Vue de Valhalla Subdivision

PART OF THE SE 1/4 OF SECTION 29 TOWNSHIP 7 NORTH, RANGE 1 EAST, SALT LAKE BASE & MERIDIAN

UNINCORPORATED WEBER COUNTY, UTAH - Date of Survey: April 2016

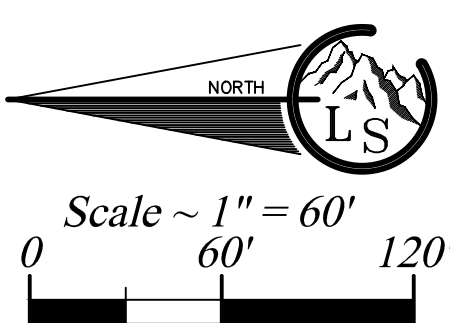
The existing location, widths, and other dimensions of all existing or platted easements within and immediately adjacent (within 30') to the tract of land to be subdivided, location of stream maintenance easement and See entry # 2531444 Subject to right of way for future road over South 50

The existing location, widths, and other dimensions of all existing or platted land drains, culverts, watercourses, wetlands, streams, corridor setbacks, flood plain within and immediately adjacent (within 30') to the tract of land to be subdivided, location of c/l of stream to determine 50ft set back and stream maintenance easement WCO 106-1-5(a)(6) this was never answered in the responses

4. Subdivisions that include lots that are partially or completely in the flood plain shall show the floodplain/floodway boundaries. And base flood elevations in 1ft increments in the flood area OR in lieu of providing base flood elevations designate areas as "non-buildable for residential or commercial structures" WCO 106-1-8(c)(1)

The existing location, widths, and other dimensions of all existing or platted land drains, culverts, watercourses, wetlands, streams, corridor setbacks, flood plain within and immediately adjacent (within 30') to the tract of land to be subdivided.

Subdivisions that include lots that are partially or completely in the floodplain shall show the floodplain/floodway boundaries. And base flood elevations in 1ft increments in the flood area OR in lieu of providing base flood elevations designate areas as "non-buildable for residential or commercial structures" WCO 106-1-8(c)(1)

per your survey response #5 I did put the wrong entry # it should be Entry # 2209661 where it does describe the south 50' right of way. Grantor being Carol Lee Storey Pilcher Grantee being Carol Lee Pilcher or her successor, as trustee of The Carol Lee Pilcher Revocable Trust established by Declaration of Trust Dated September 20, 2006 Grantee, of Liberty, Weber County

RESPONSE: The Zone A lines have been attached to this plat. They are digitized from FEMA FIRM panel 228 of 600 Map Number 49057C0228F revised June 2, 2015, there are no base flood elevations for this area. It is also my understanding that the flood zone is in the process of being modified so that they can be removed from the plat and we will not need to show "non-buildable" areas. until the flood zone modification happens still need to provide base flood elevations or designate areas as "non-buildable for residential or commercial structures" WCO 106-1-8(c)(1)
